**ALL INDIA INSTITUTE OF MEDICAL SCIENCE
DR. B.R.A INSTITUTE OF ROTARY CANCER HOSPITAL
(STORE SECTION)**

T.NO.IR-04/IRCH/R.O/2024-25(CPP)

CORRIGENDUM

Corrigendum/Addendum- 1

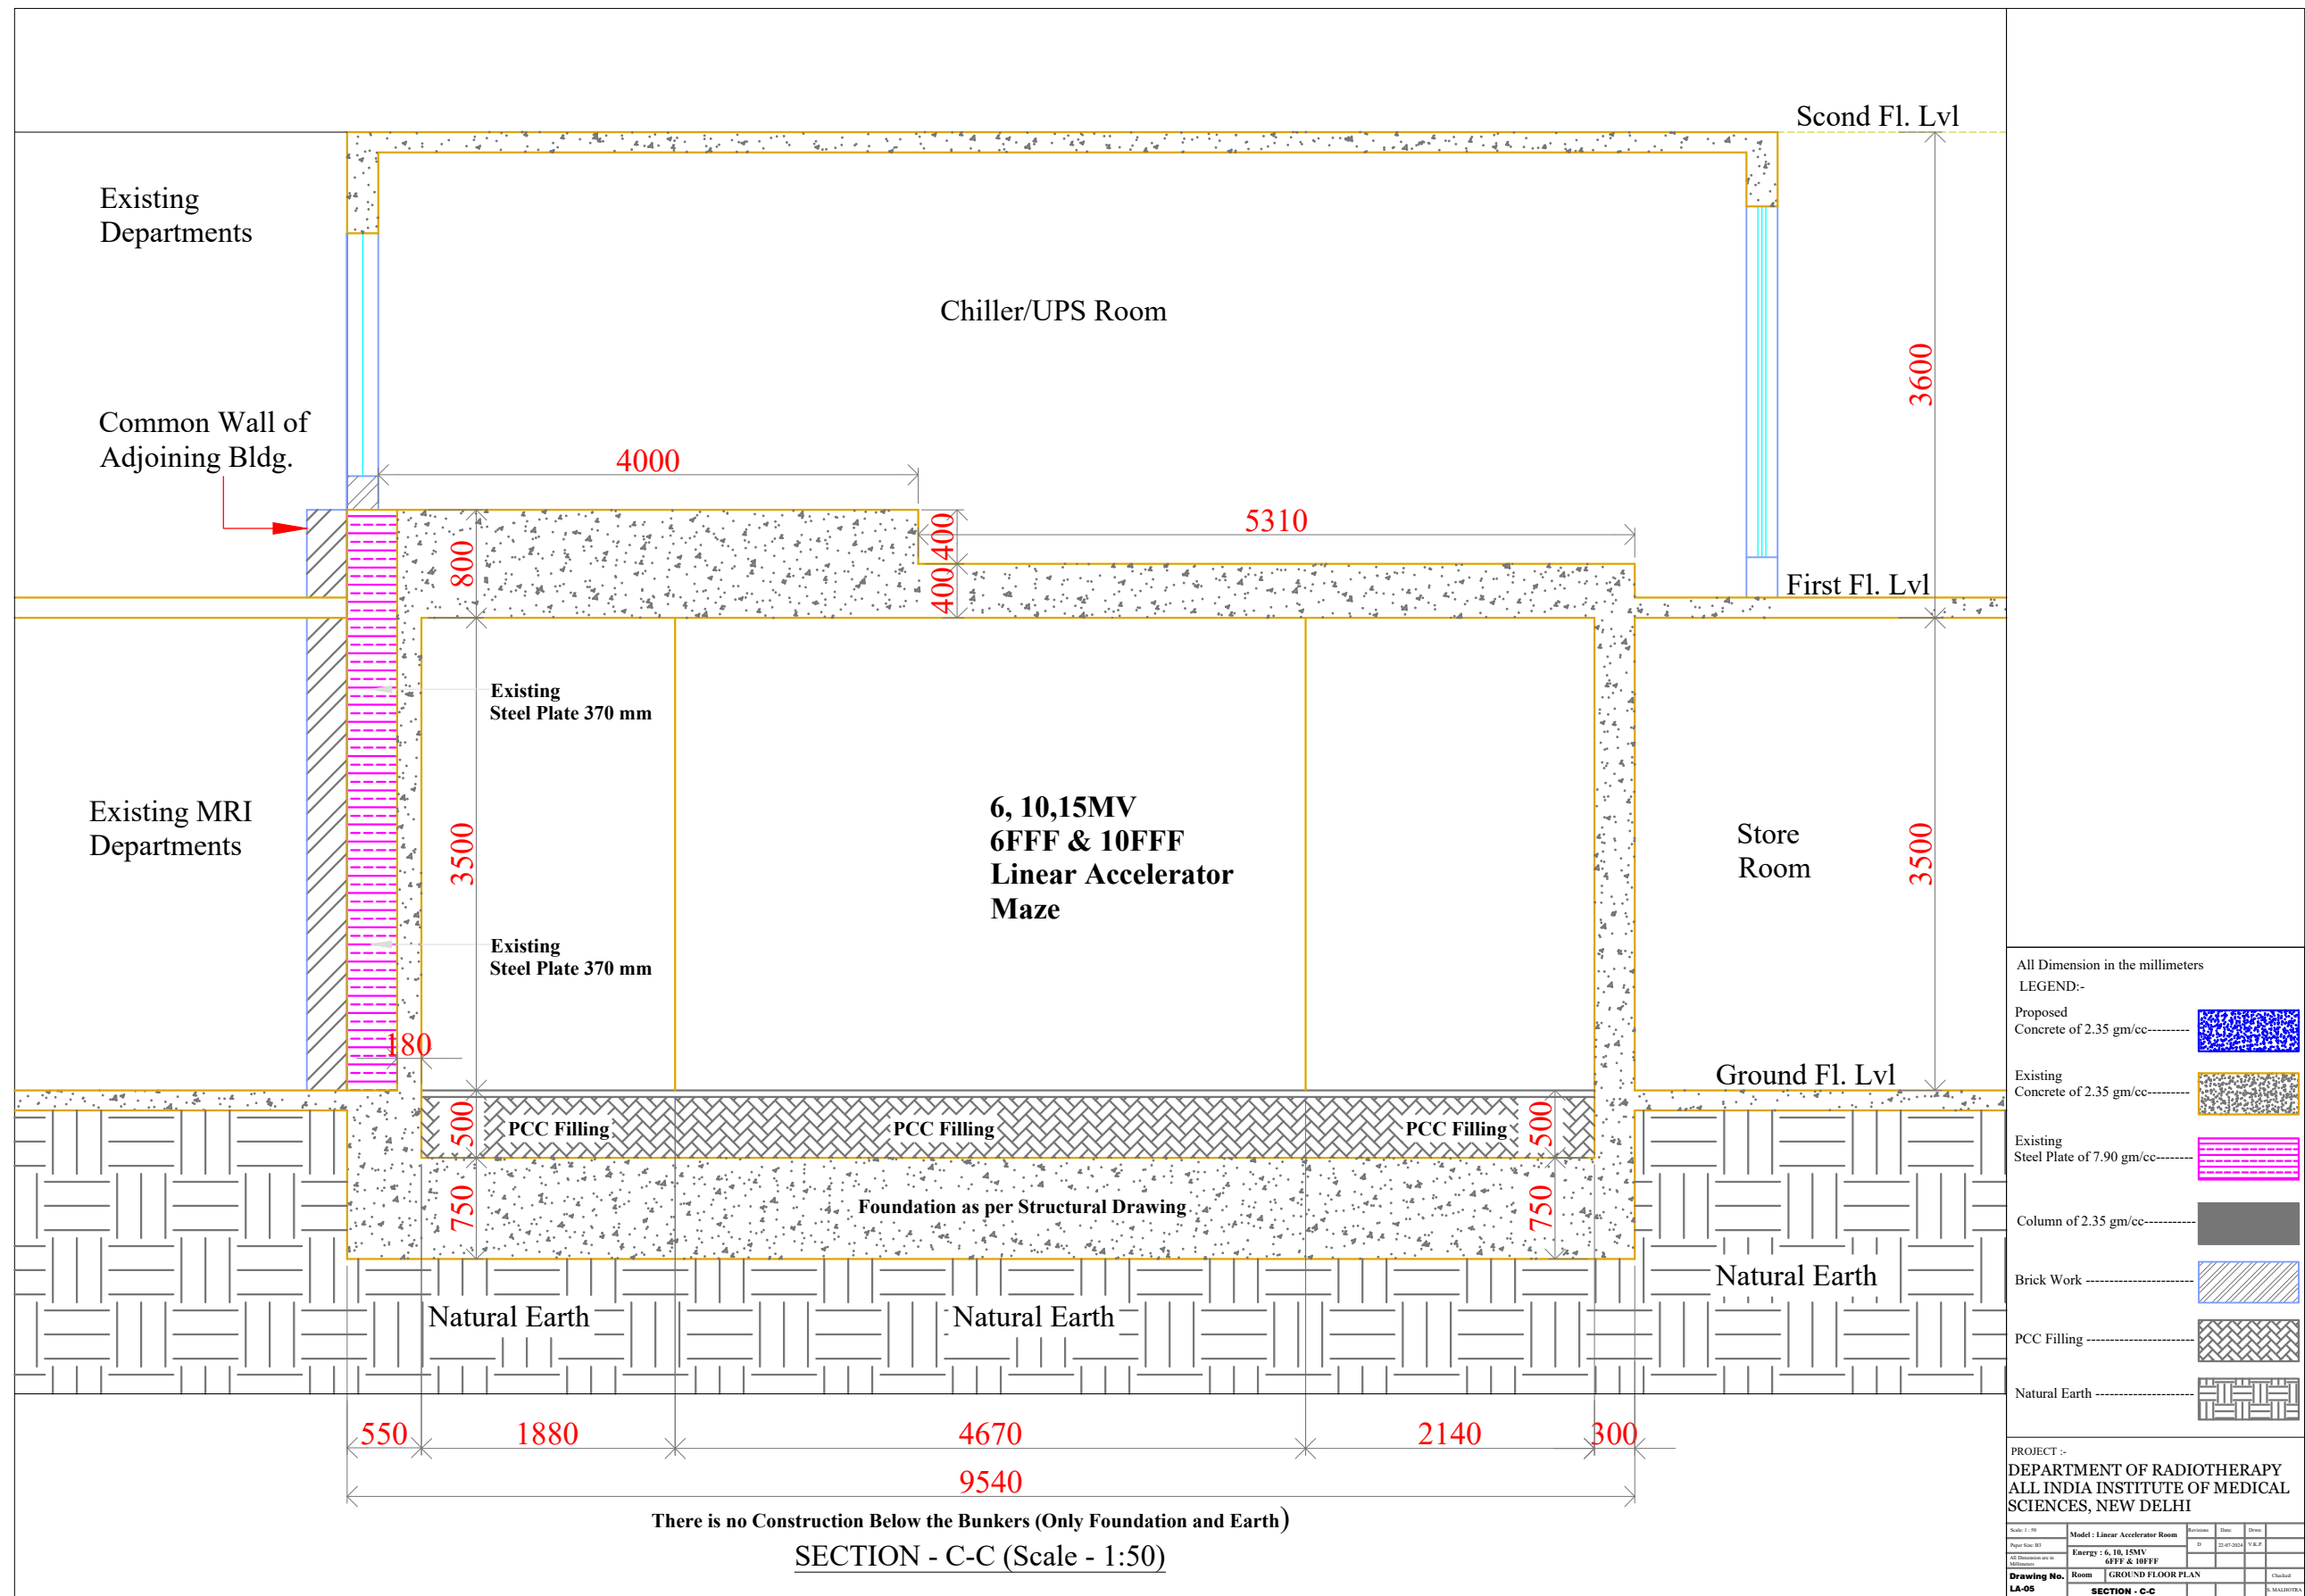
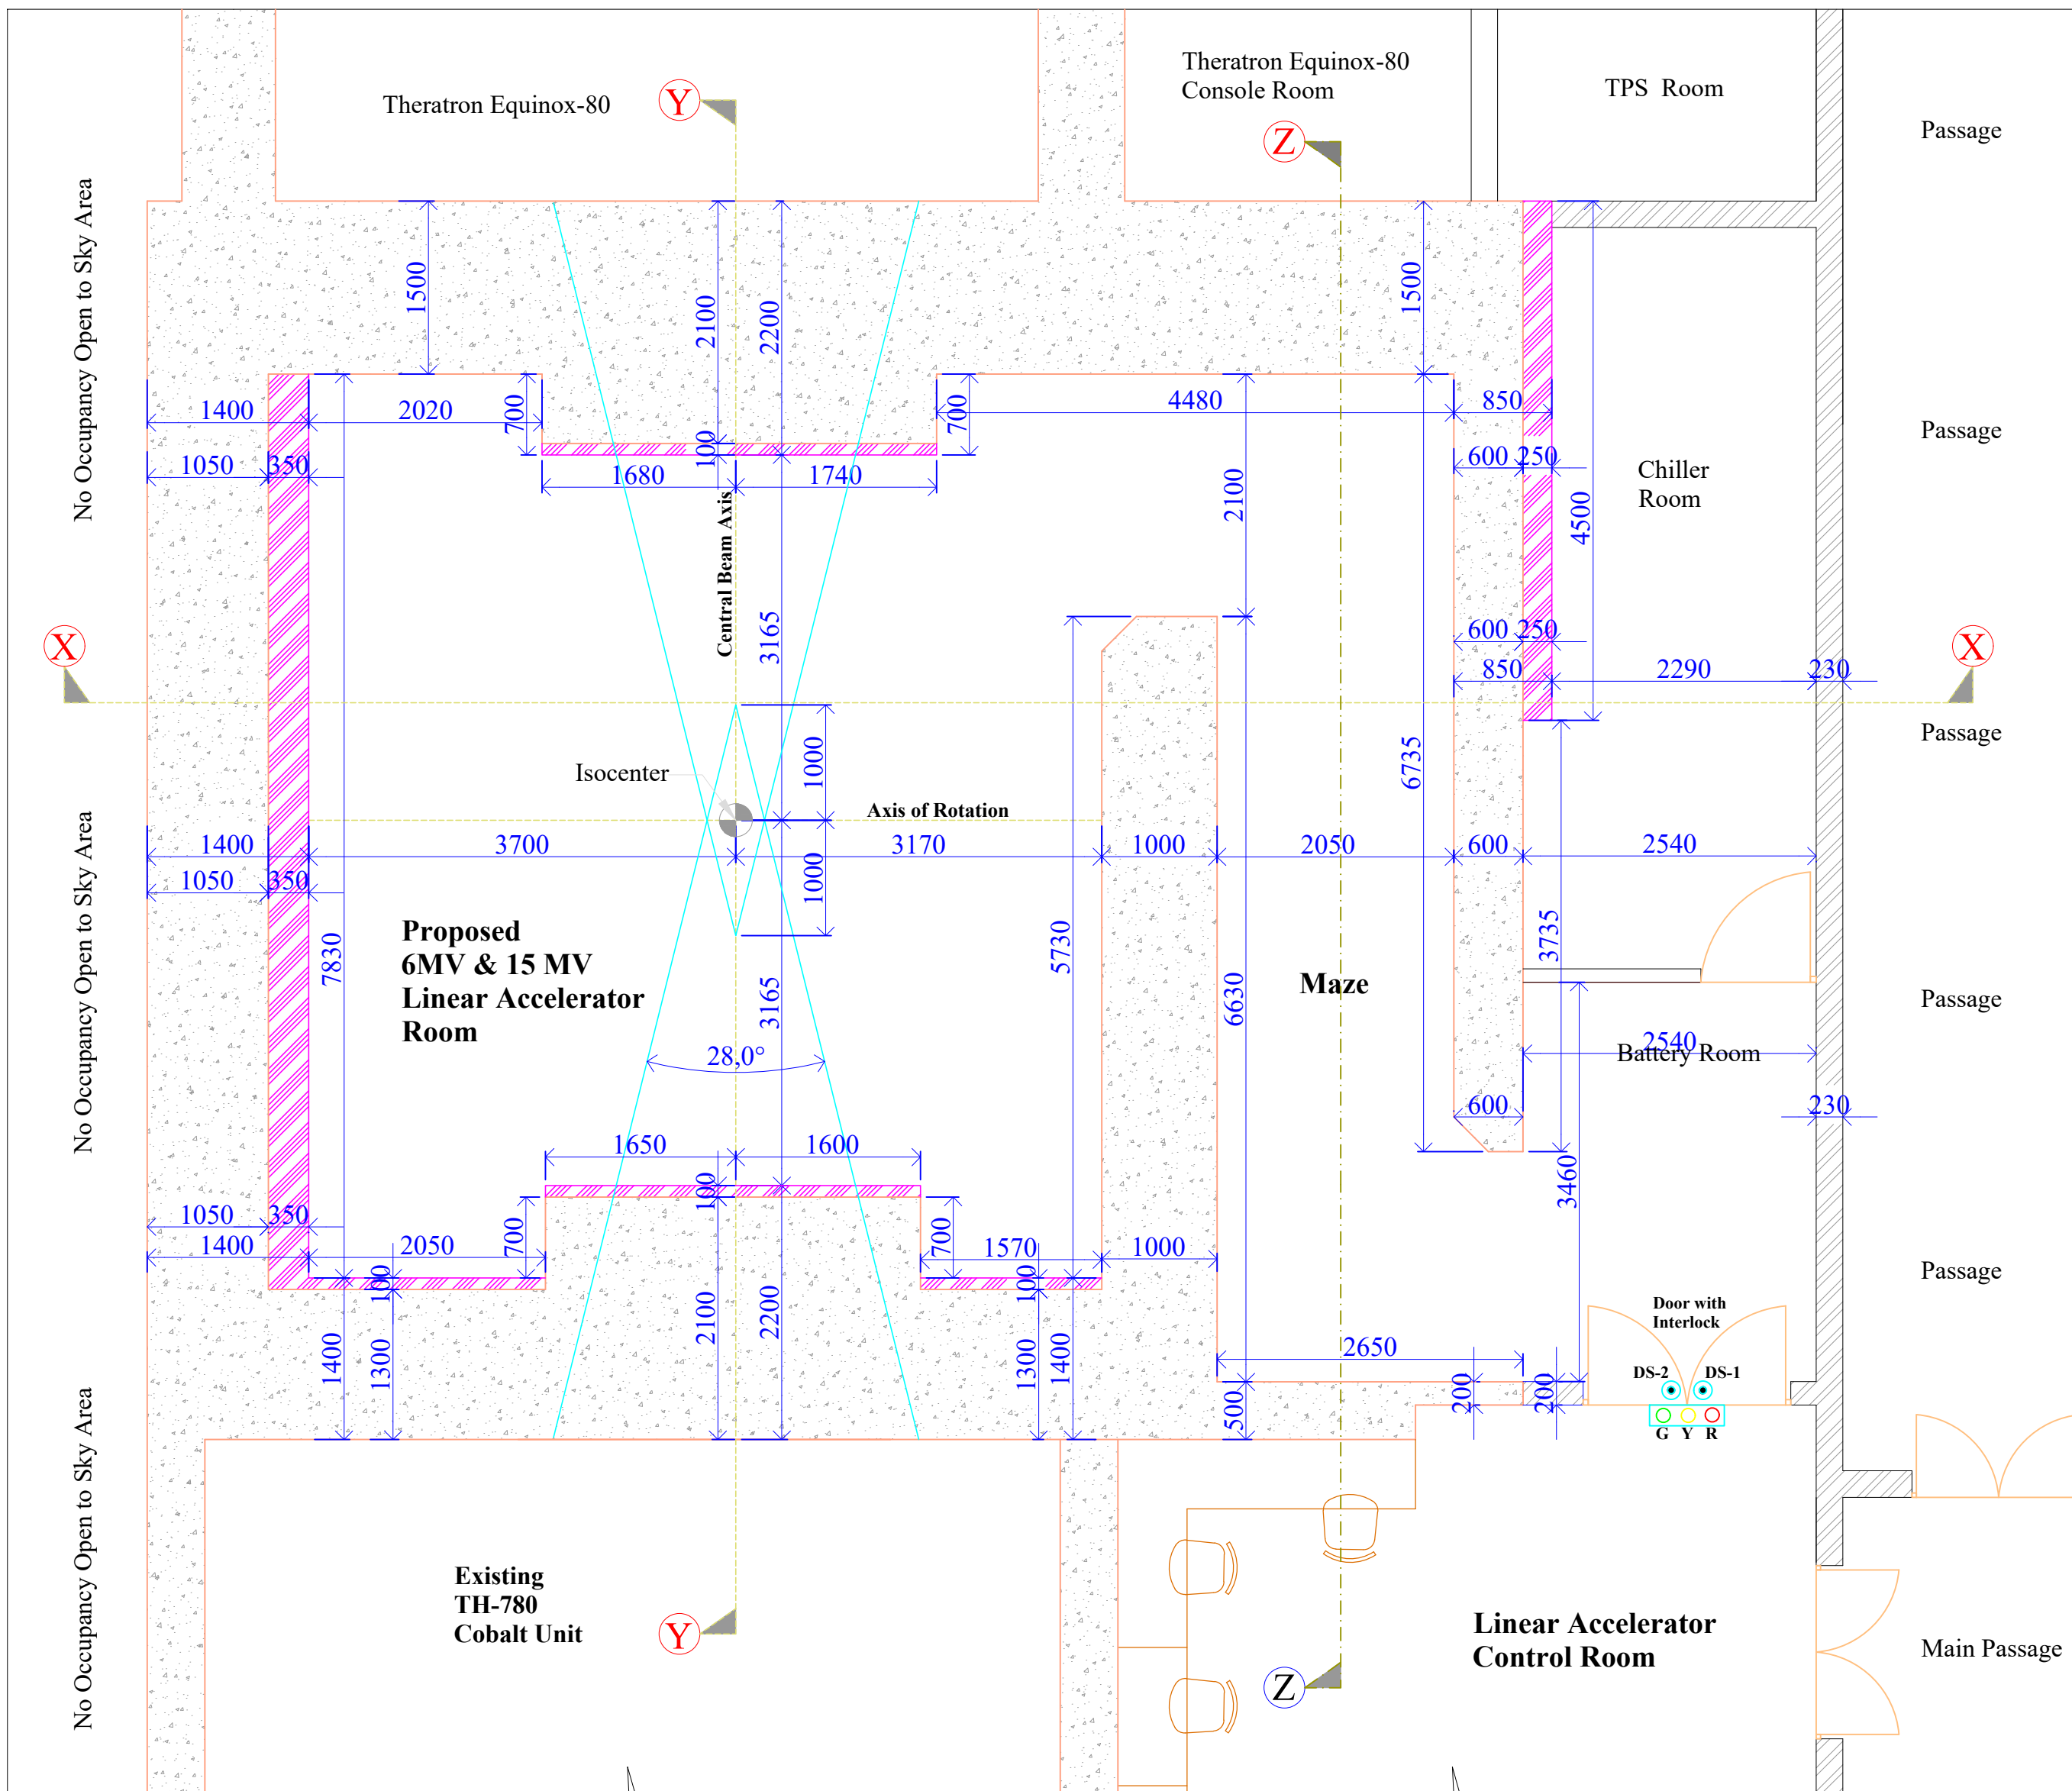
1	Point No.2 Page 78	2. The bunker / facility shielding work requirement is entirely the vendor responsibility. The successful vendor should do the necessary shielding works as per the AERB approved layout drawing and the same is given in the tender. The cost of the facility site modification work should be quoted separately, and this cost will be considered for L1 calculation.	2. The bunker / facility shielding work requirement is entirely the vendor responsibility. The successful vendor should do the necessary shielding works as per the AERB approved layout drawing and the same is given in the tender. The cost of the facility site modification work should be quoted separately, and this cost will be considered for L1 calculation. (i) The Chiller and UPS room for Linac bunker at Room No 9, Main RT, is at the room at first floor above the maze area as shown in sectional drawing (A-A) of the attached layout drawing. The TPS room is situated above the control console room of the proposed bunker. (ii) The Chiller and UPS room for Linac bunker at Room No 33, Ground Floor, DRBRAIRCH, are shown in room layout plan of the attached layout drawing. The TPS room is situated at room number 34 & 37, Ground Floor, DRBRAIRCH.

5.	Page 83-87;	Attached drawings	The legible layout drawings in pdf format are attached.
Dosimetry Items :-			
		Relative Dosimetry Equipment	
1	Page No. 73, Sr. No. 1	Radiation Beam Data Acquisition System 3D scanning water phantom of square /rectangular shape for linear accelerator beam commissioning dosimetry and annual QA. The system shall have automatic setup for beam center adjustment and auto field alignment capability. The system shall consist of 3D scanning water tank, lift table, water reservoir, electrometer / controller, beam data acquisition software with latest laptop computer, two approximately 0.125cm ³ or equivalent water-proof ionization chambers and associated holders and cables.	3D scanning water phantom of square /rectangular/cylindrical shape for linear accelerator beam commissioning dosimetry and annual QA. The system shall have automatic setup for beam center adjustment and field alignment capability. The system shall consist of 3D scanning water tank, lift table, water reservoir, electrometer/controller, beam data acquisition software with latest laptop computer, two approximately 0.125cm ³ or equivalent water-proof ionization chambers and associated holders and cables.
